# HITACHI SEMICONDUCTOR TECHNICAL UPDATE

DATE	18 February 2000	No.	TN -SH7-212A /E
THEME	SH3 / SH3DSP have additional information on RTC		
CLASSIFICATION	<input type="checkbox"/> Spec. change <span style="margin-left: 200px;"><input type="checkbox"/> Limitation on Use</span> <input checked="" type="checkbox"/> Supplement of Documents		
PRODUCT NAME	HD6417708,HD6417708S,HD6417708R,HD6417718R,HD6417707,HD6417709,HD6417709A,HD6417729		
REFERENCE DOCUMENTS	SH7708 Series Hardware manual	SH7707 Hardware manual	Effective Date Eternity
	SH7709 Hardware manual	SH7709A Hardware manual	From
SH7729 Hardware manual

DATE	15 November 2000	No.	TN-SH7-278A/E
THEME	SH3, SH3-DSP An error in writing of "Mask All Interrupts (MAI) bit"		
CLASSIFICATION	<input type="checkbox"/> Spec. change <input type="checkbox"/> Limitation on Use <input checked="" type="checkbox"/> Supplement of Documents		
PRODUCT NAME	SH7707, SH7709, SH7709A, SH7729		
REFERENCE DOCUMENTS	Hardware Manual s SH7707: ADE-602-137 Rev.1.0, SH7709: ADE-602-123B Rev.2.0 , SH7709A: ADE-602-187B Rev.3.0, SH7729: ADE-602-157A Rev.2.0		Effective Date    Eternity
			From                      Now

Fig.1 Using the Periodic Interrupt Function

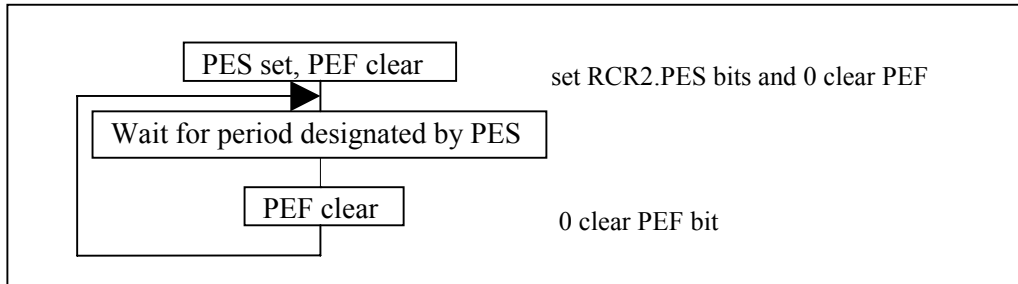
1. Additional information about Periodic interrupt on Real Time Clock (RTC)

Fig. 1 shows how to use the periodic interrupt function.  
 The periodic interrupt function can occur the interrupt periodically which designated by RCR2.PES bits. RCR2.PEF bit is set to 1 after the period designated by the RCR2.PES bits or written 1. When the PEF bit become 1, the periodic interrupt occurs. PEF bit should be set to 0 when setting PES bits or when the interrupt occurs.
